MEMORANDUM

ADEILADU 9 ANNEDD / ERECTION OF 9 DWELLINGS

BERSHAM SPORTS AND SOCIAL CLUB BERSHAM ROAD BERSHAM WREXHAM
Grid Ref: E 331351 N 349285

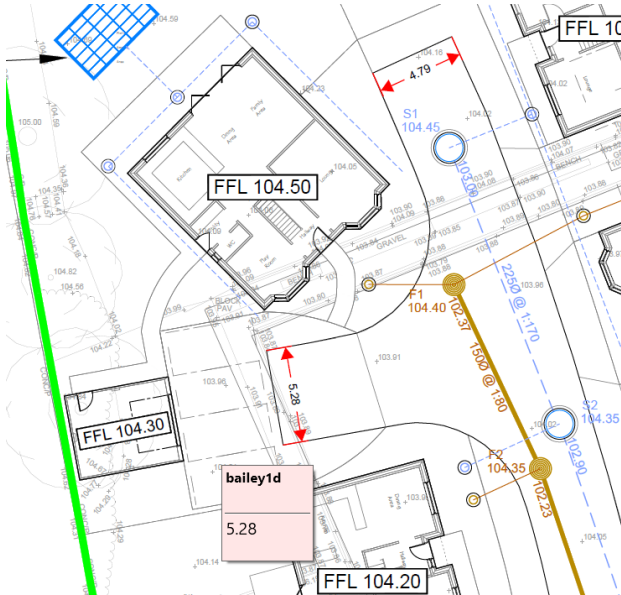
Visibility splays appropriate for the current speed limit should be clearly highlighted on the proposed layout. It is noted that effective traffic calming exists both ways along the B5099

Details of the access to the Scottish Power substation will be required with visibility splays highlighted. Consideration should be given to vehicle turning within the space to avoid reversing out. Have Scottish Power commented on the proposed arrangement, with doors facing away from the proposed access? Would Scottish Power reverse in?
